Pentium® Processor Specification Update

Release Date: March 1998

Order Number: 242480-035

Figure14-1. Maximum Undershoot Level, Undershoot Threshold Level, and Undershoot Threshold Duration

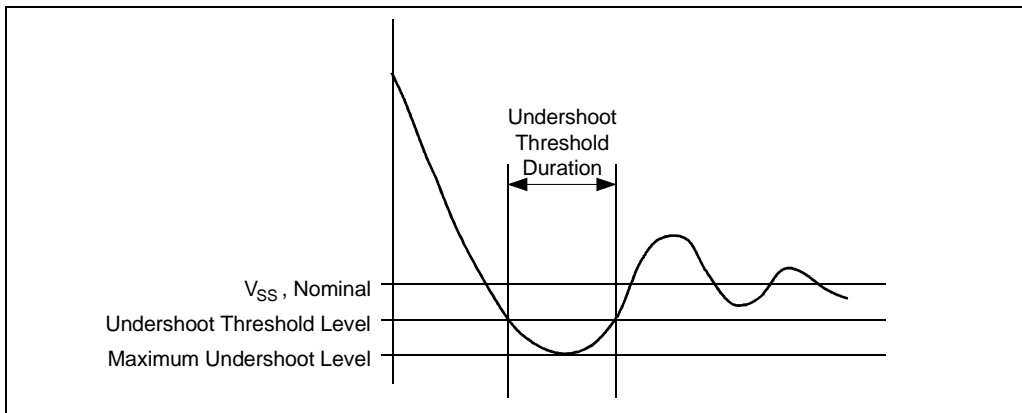
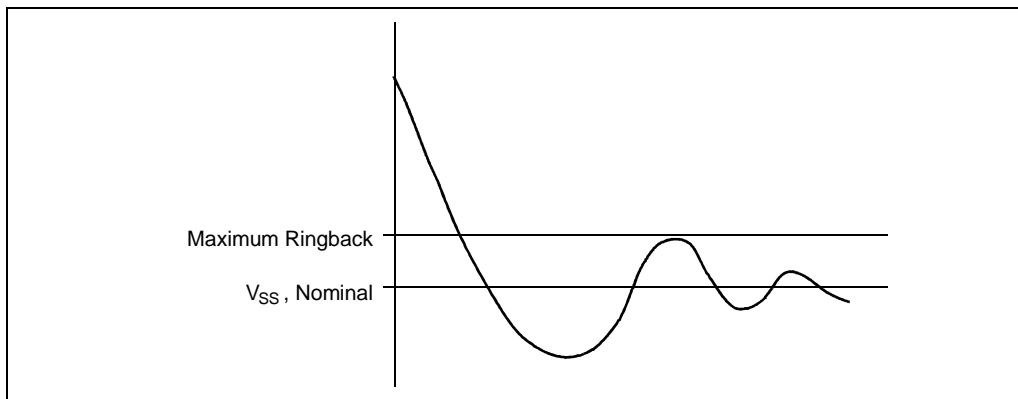
MAXIMUM RINGBACK SPECIFICATION: The maximum ringback of CLK associated with its low state (undershoot) must not exceed 0.8V as shown in Figure 14-1.

MAXIMUM UNDERSHOOT AND MAXIMUM RINGBACK SPECIFICATIONS: The display should show continuous sampling (e.g., infinite persistence) of the waveform at 500 mV/div and 5 ns/div (for CLK) for a recommended duration of approximately five seconds. Adjust the vertical position to measure the maximum undershoot and associated ringback. There is no allowance for crossing the maximum undershoot or maximum ringback specifications.

UNDERSHOOT THRESHOLD DURATION SPECIFICATION: A snapshot of the clock signal should be taken at 500 mV/div and 500 pS/div (for CLK). Adjust the vertical position and horizontal offset position to view the threshold duration. The undershoot threshold duration is defined as the sum of all time during which the clock signal is below -0.5V within a single clock period. The undershoot threshold duration must not exceed 20% of the period.

This undershoot specifications are illustrated graphically in Figure 14-1 and Figure 14-2.
